Mewbourne Oil Company requests approval to make the following changes to the approved APD (10400084788, 30-025-53219)

OPERATOR'S NAME:	MEWBOURNE OIL COMPANY
WELL NAME & NO.:	BUSHWOOD 21/16 FED COM 523H
APD ID:	10400084788
LOCATION:	Section 21, T.19 S., R.33 E. NMP.
COUNTY:	Lea County, New Mexico ▼

*Previously known as BUSHWOOD 21/16 B2FC FED COM 1H. Changes approved through engineering via **Sundry 2803559** on 8/22/2024. Any previous COAs not addressed within the updated COAs still apply.*

Figure 3. Cactus 9 5/8" 5M offline cementing tool. Pressure rating limited by the lesser of 5M tool rating or the 9 5/8" pup joint and casing.

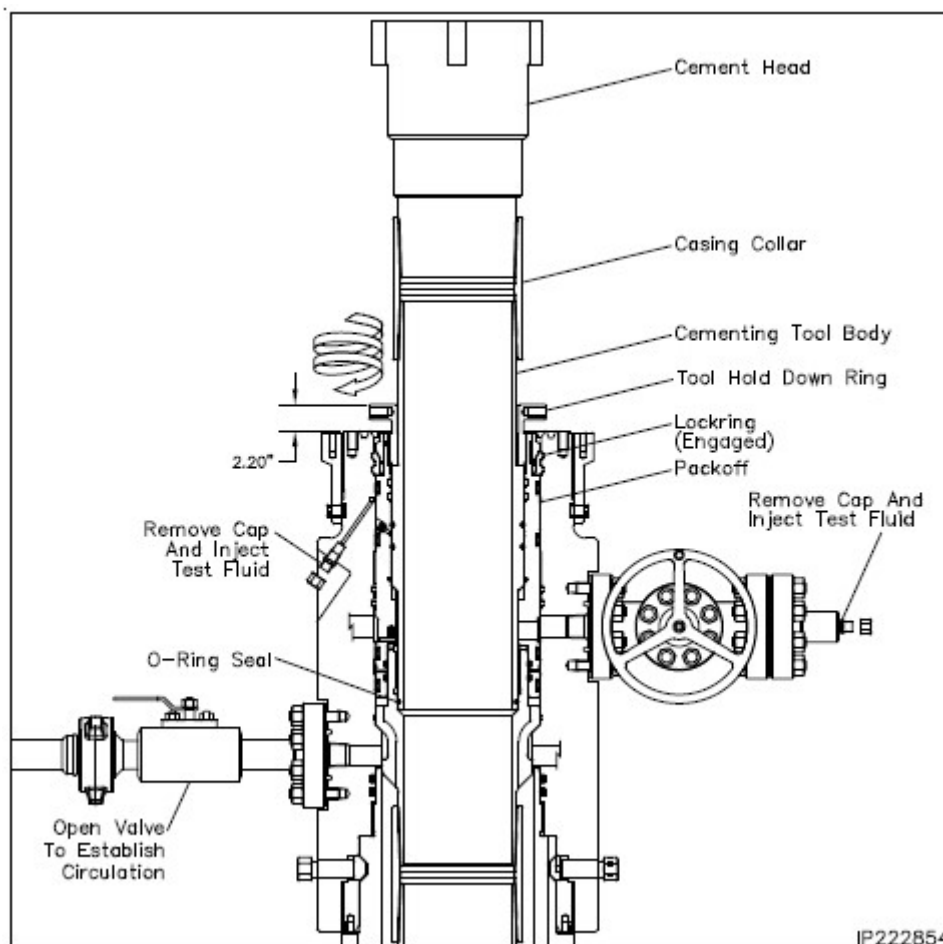
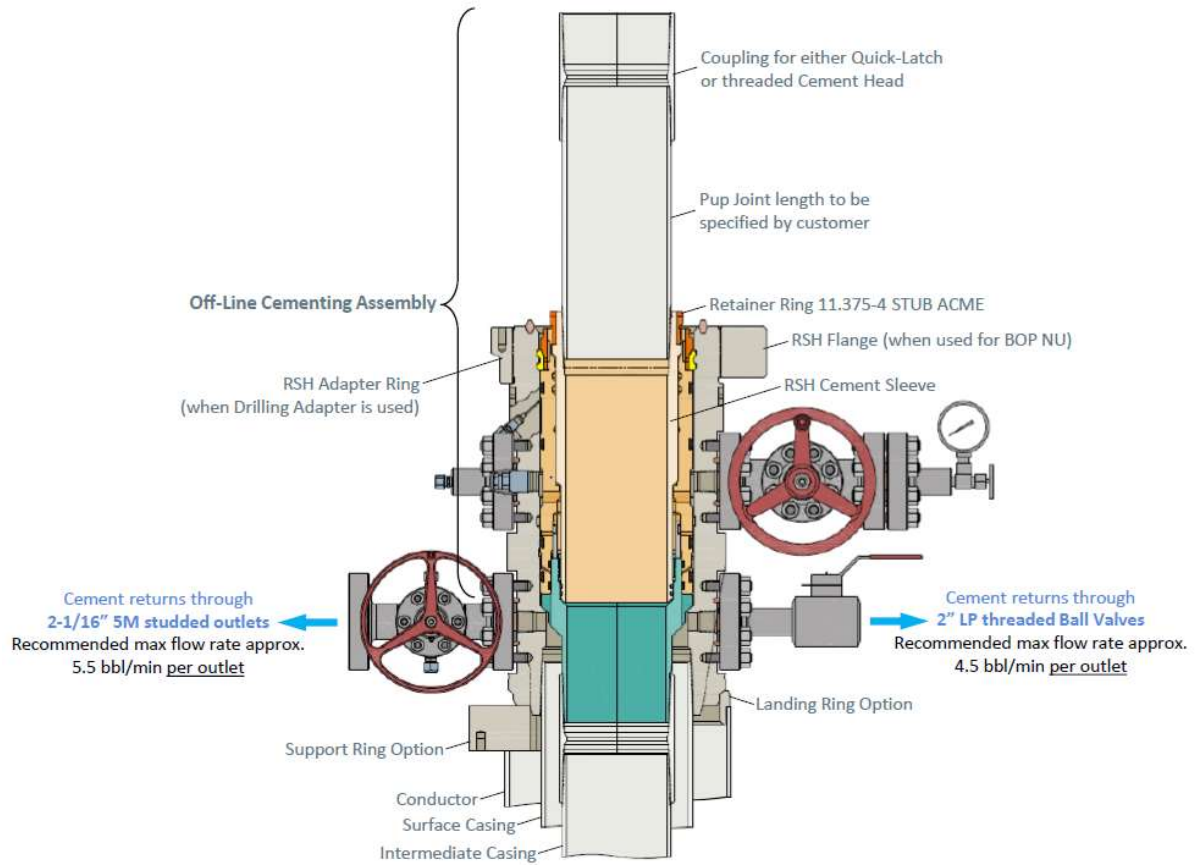
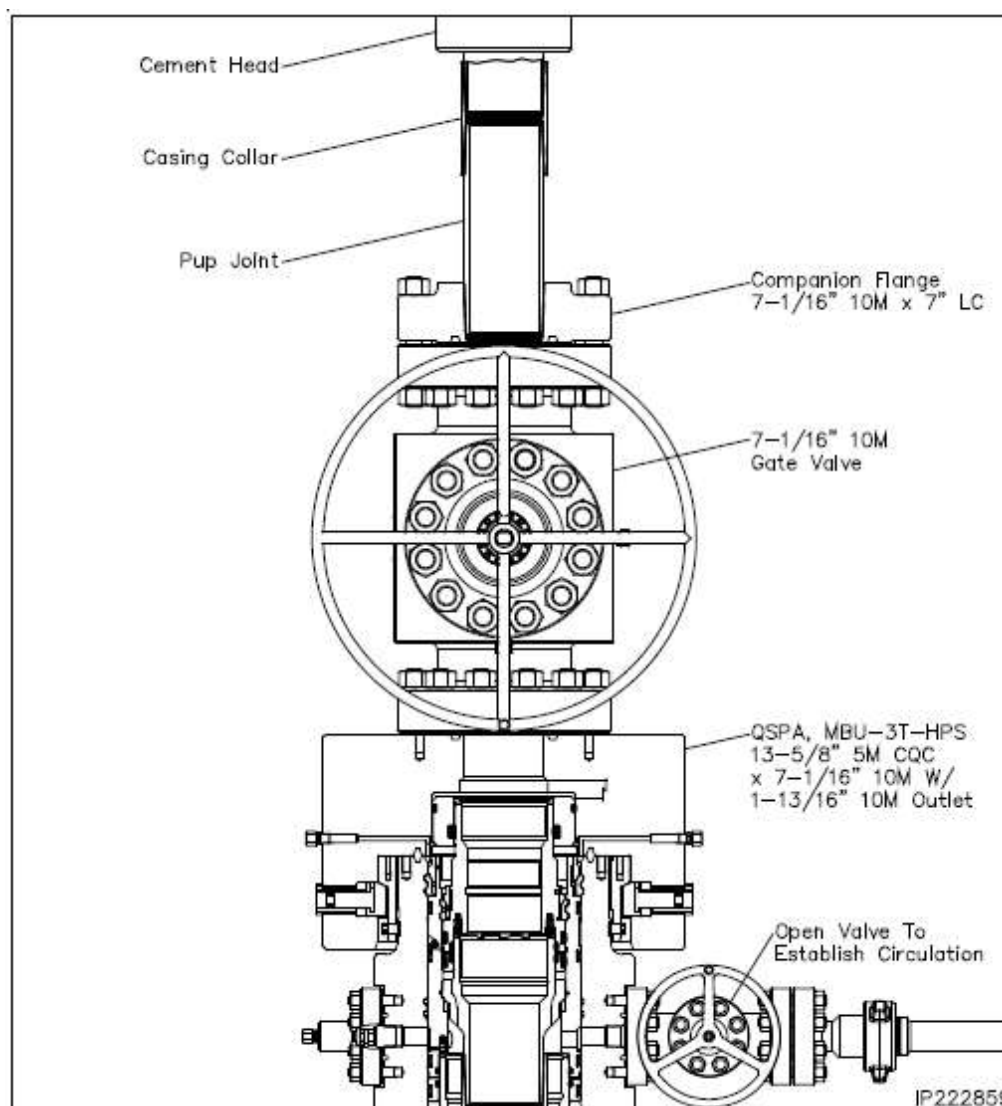
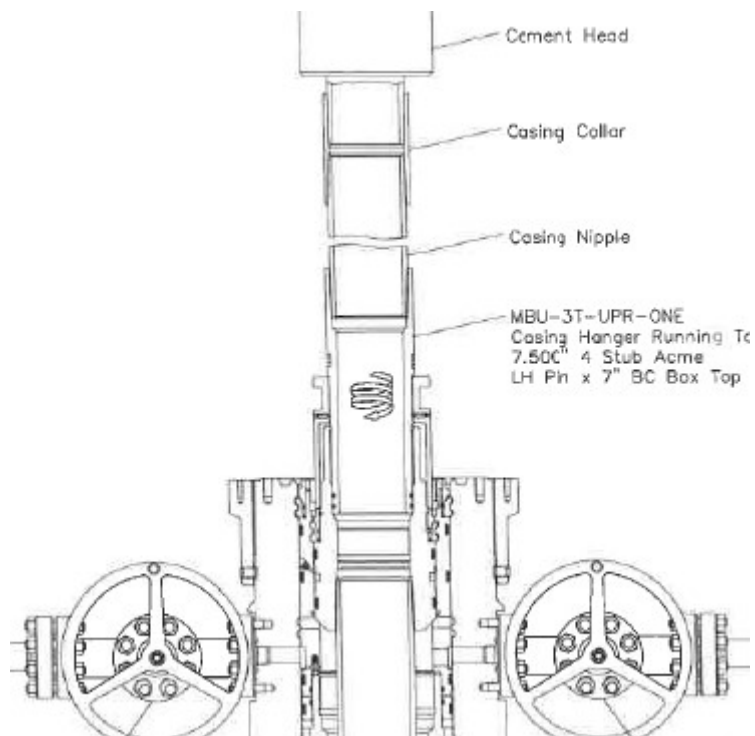
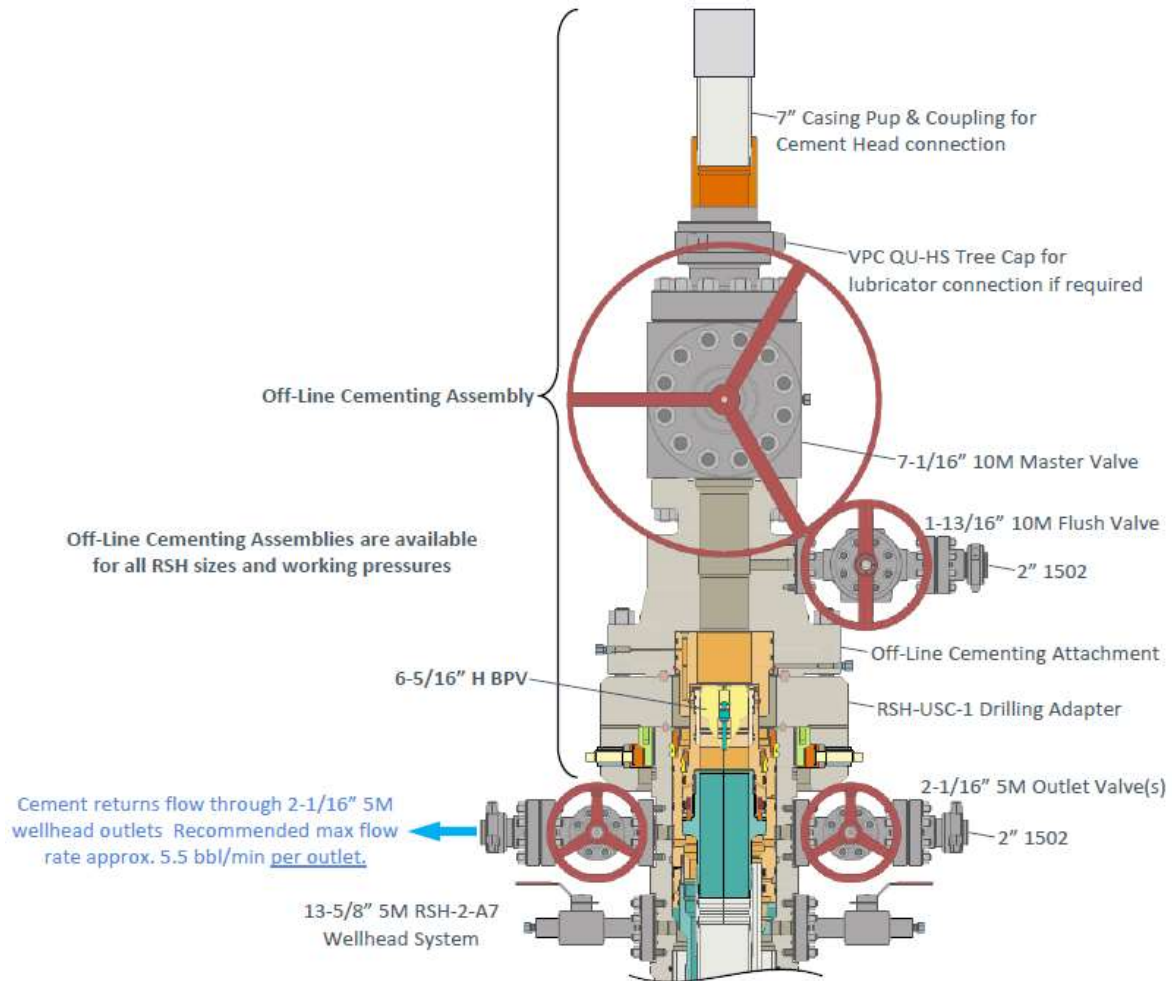
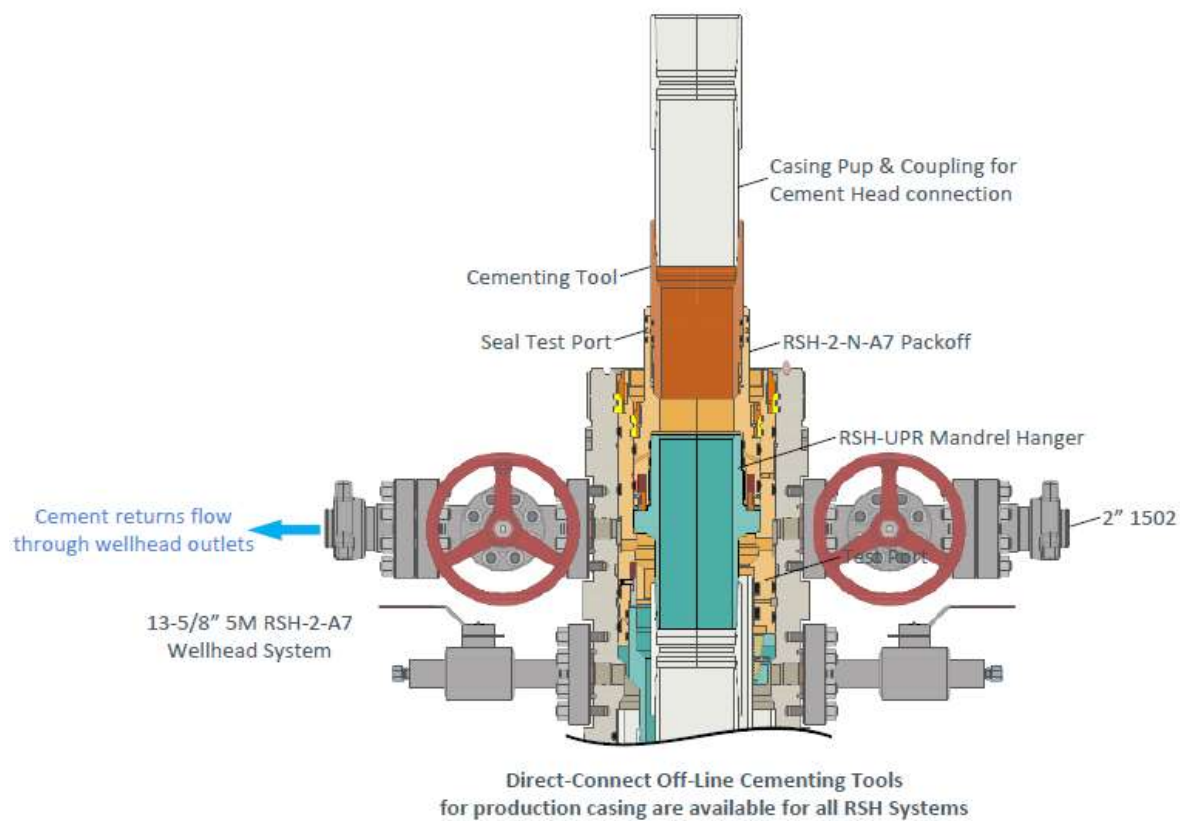
10. Make up offline cement tool using forklift per wellhead manufacturer (Fig. 3 - 8).
11. Make up cement head on top of offline cement tool.
12. Commence cement operations.
